# **Ordinary Meeting of Council**

14 June 2023

ITEM 9.1 MODIFICATION TO DEVELOPMENT APPLICATION DA.2021.1628 - TELECOMMUNICATIONS FACILITY - 34 POWELL DRIVE, CARWOOLA

### Section 4.55(1A) - Assessment Report - DA.2021.1628.A

Figure 20: DA.2021.1628 Approved plans

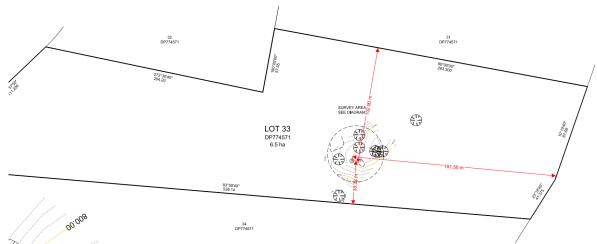
The modification proposes an altered location as constructed on site that is now 89.74m from the northern boundary, 52.05m from the southern boundary and 185.25m. This results in 13.1m reduction in the northern setback, 13.7m increase in the southern setback and a 3.69m increase in the eastern/rear boundary setback.

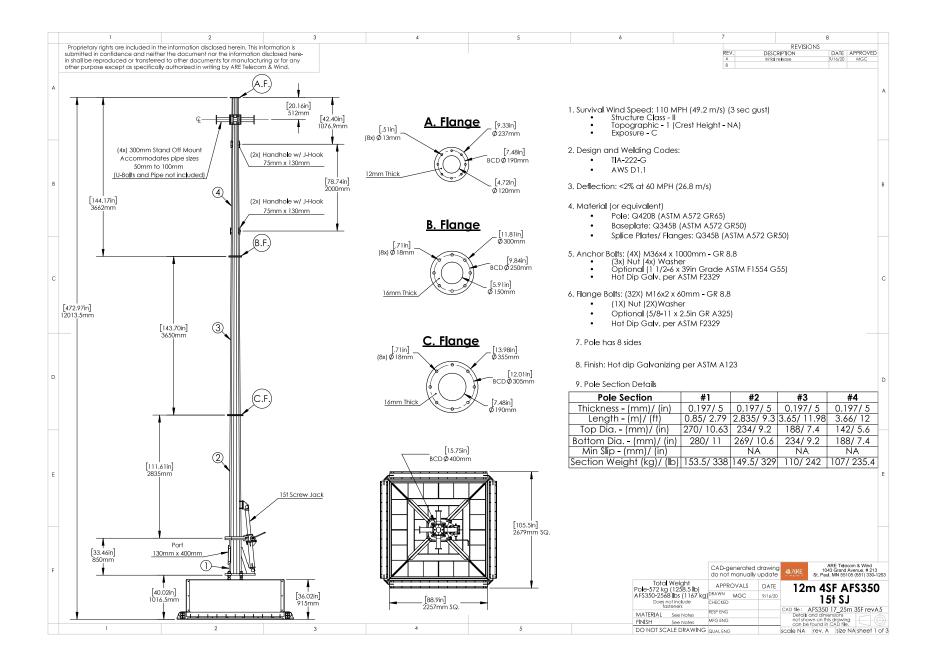
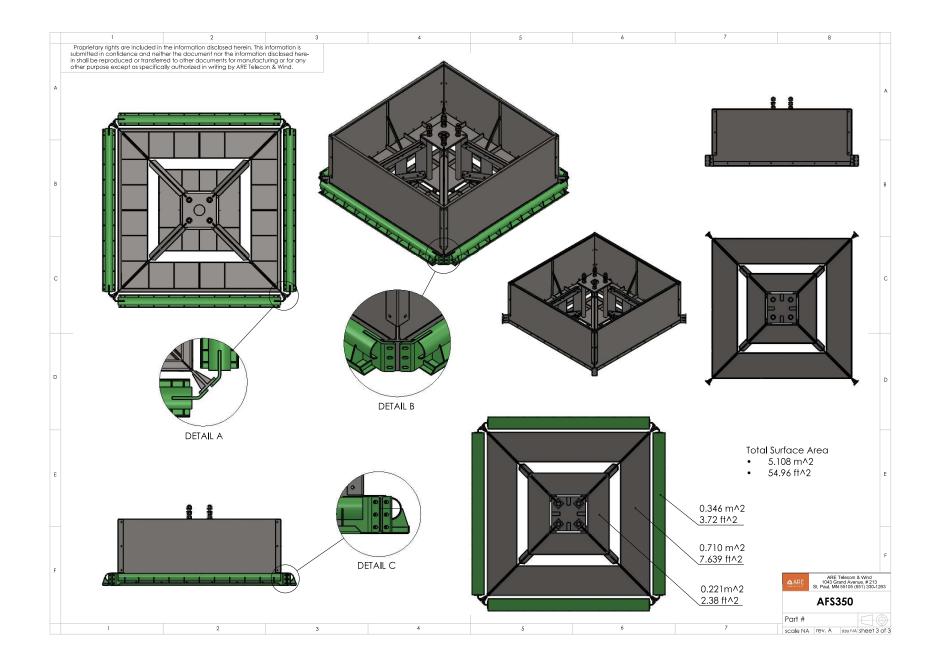
- a) Drawing identified as sheet 1 of 3 titled 12m 4SF AFS350 15t SJ revision A is again provided and continues to indicate that the tower will have a height of 12013.5mm (12.01 metres). Contradicting this information is the document titled YLess4U Planning Pathway for: POWELL which states that the tower will have a height of no greater than 15 metres. It is our understanding that the tower was approved by Council at 12 metres.

A request for further information has been made to the applicant; revised documents have been received that confirm the height of the structure to the top of the telecommunications tower is 12m with the base of the tower buried within the ground level by 1016mm therefore, the telecommunications tower height is approximately 11m from the existing ground level to the top of the tower.
